**COUNTY OF SAN MATEO**  
**PLANNING AND BUILDING**

**SUBJECT: Coastside Design Review Continuation**  
208 Magellan Avenue, Miramar  
APN 048-031-200; County File No. PLN 2018-00490

NEW MITHAL RESIDENCE  
MAGELLAN AVENUE  
HALF MOON BAY, CA

**EXTERIOR ELEVATIONS**

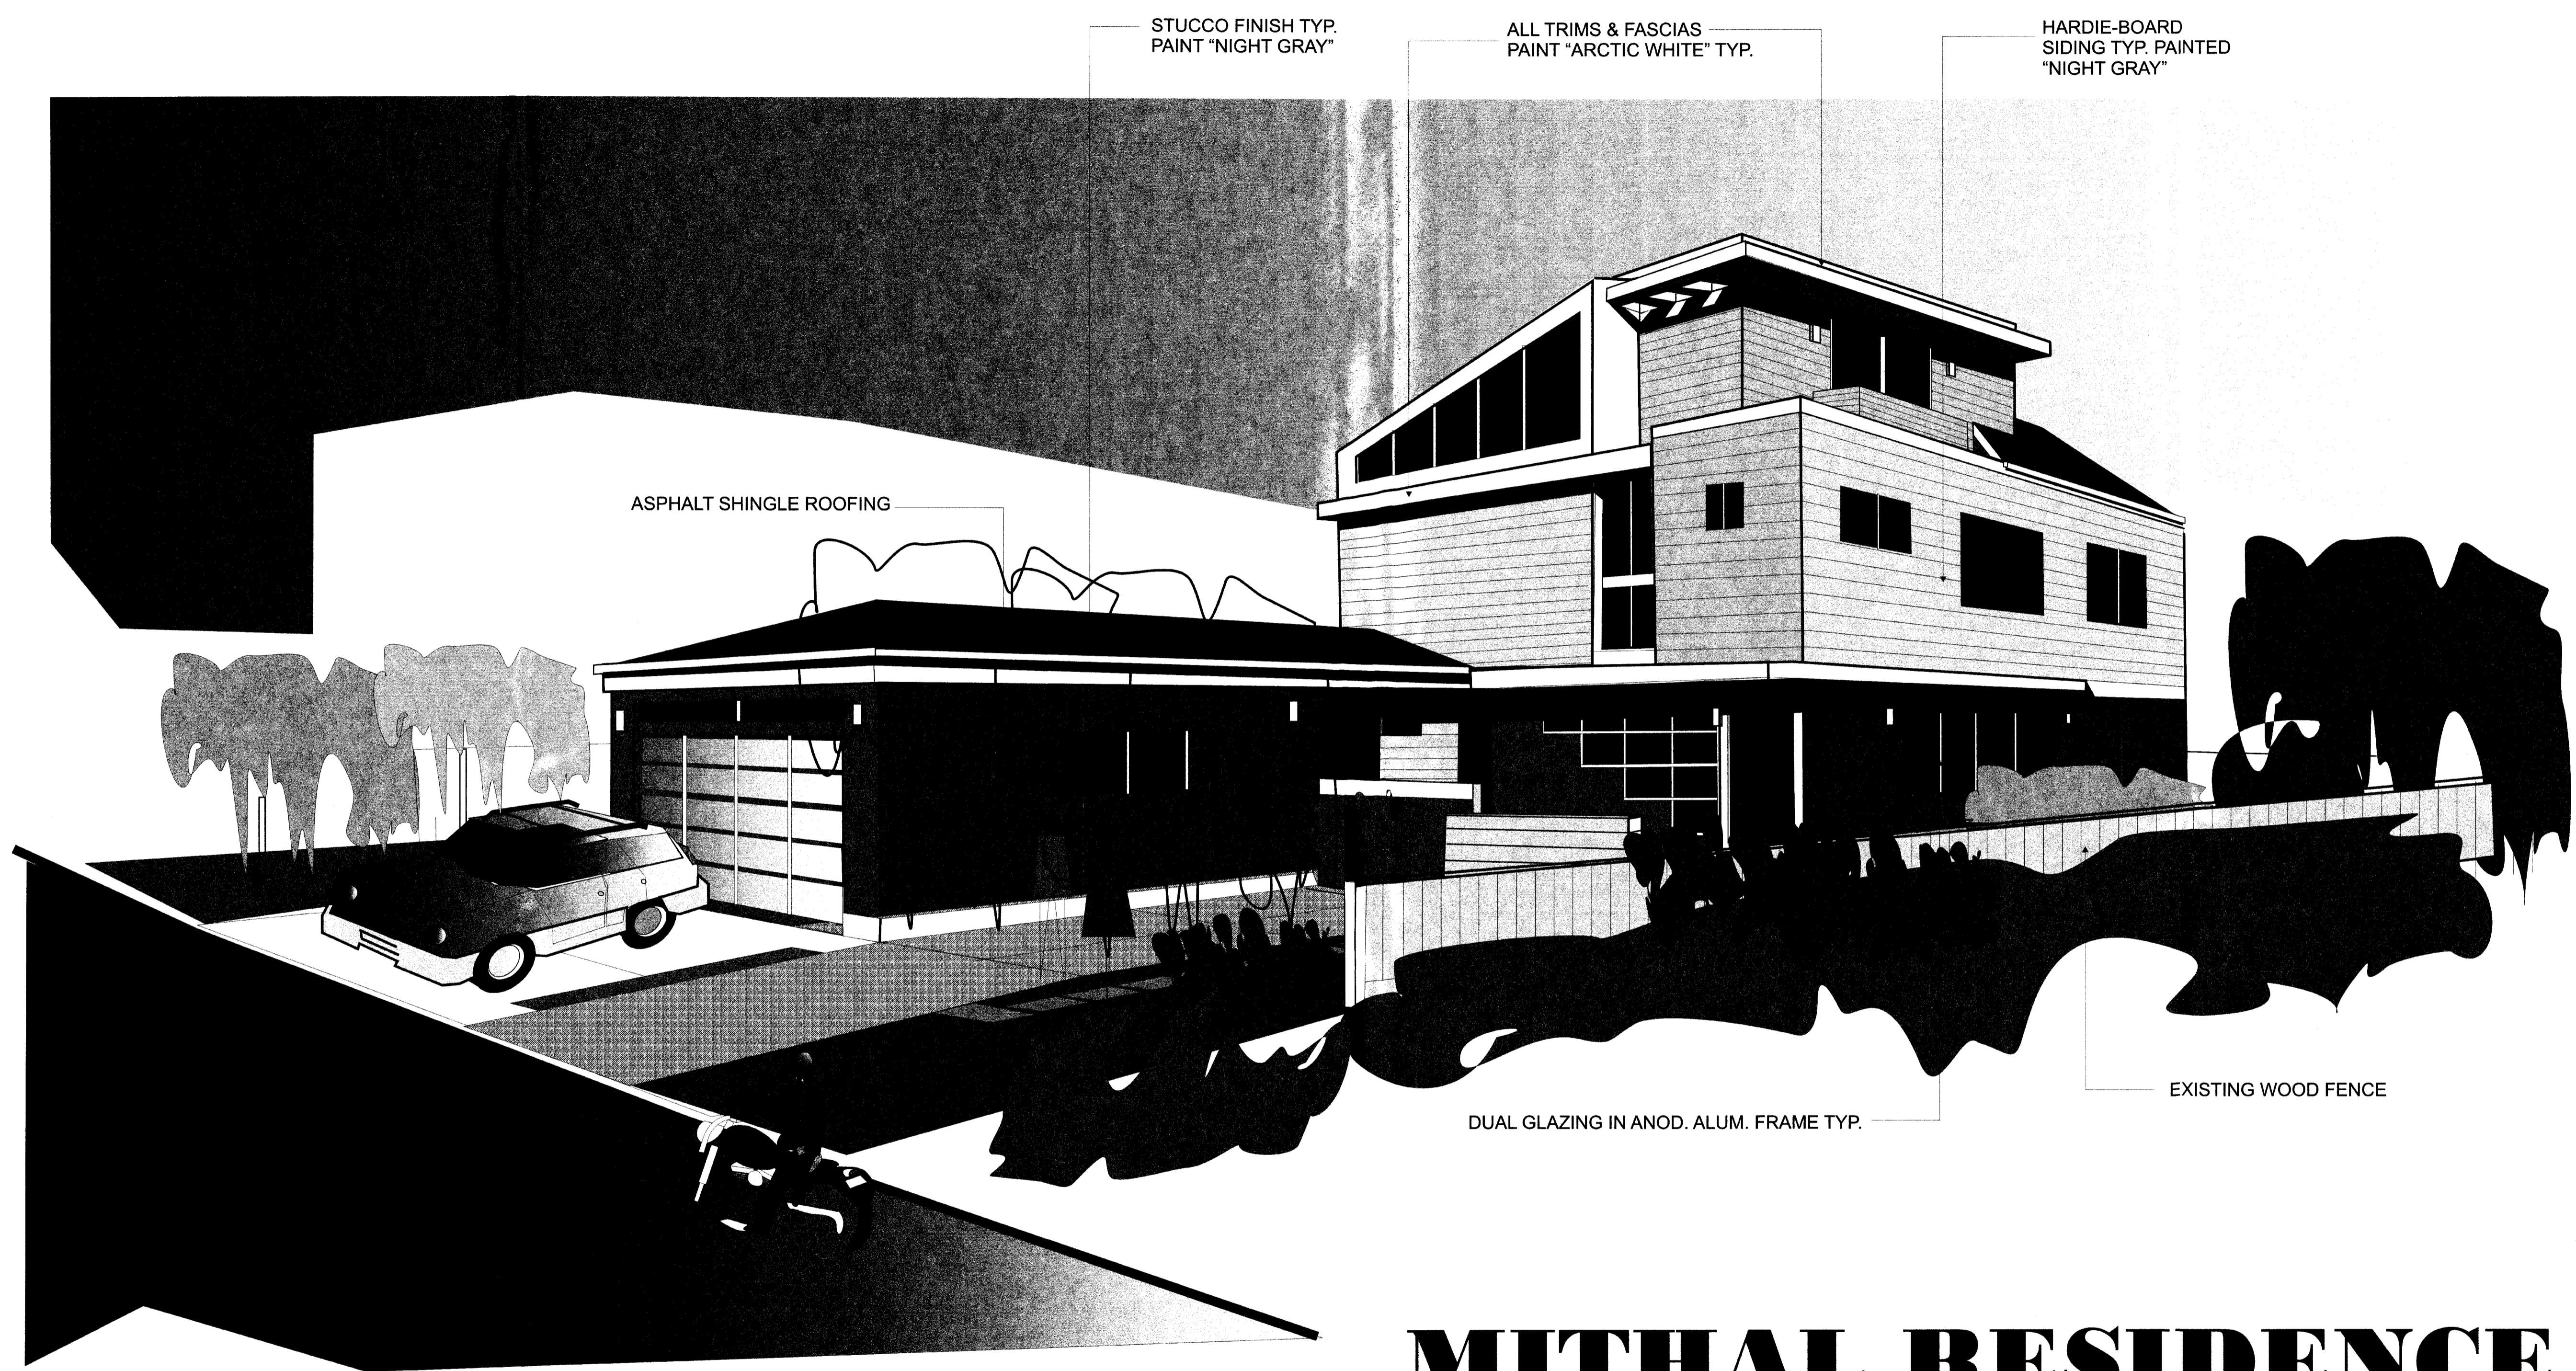
1. Provide updated floor elevations on elevation and section views, to be consistent with floor plans and civil plans.
2. Add lights to outside corners of doors on balconies and re-consider functionality of rear balconies.
3. Add outside light by guest room side door onto courtyard.

4. Provide two versions of front elevations, one showing screen wall and one with section elevation through guest study facing the front door.
5. Provide screen wall height and material specification.

6. Provide details of gate and fence.
7. Eliminate redundant entry landing.
8. Provide articulated stucco walls on first floor; show architectural reveal pattern.
